## User Safety Notice

### 30 ft. / 9 m. Workman® Self-Retracting Lanyard

October 28, 2015

Yellow Tamper Evident Paint

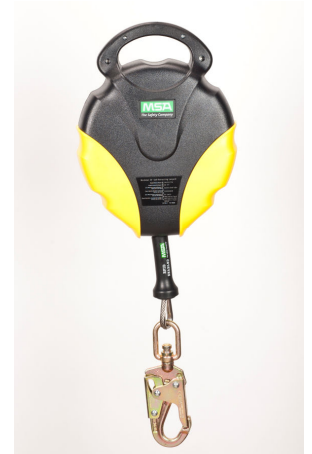
Please note that the replacement SRLs may also have a “date made” from 01-2015 through 08-2015, but include yellow tamper evident paint on the exterior housing screw heads near the handle, as shown in the photo below. These SRLs are new units that were factory upgraded to include a new brake assembly and are acceptable for use.
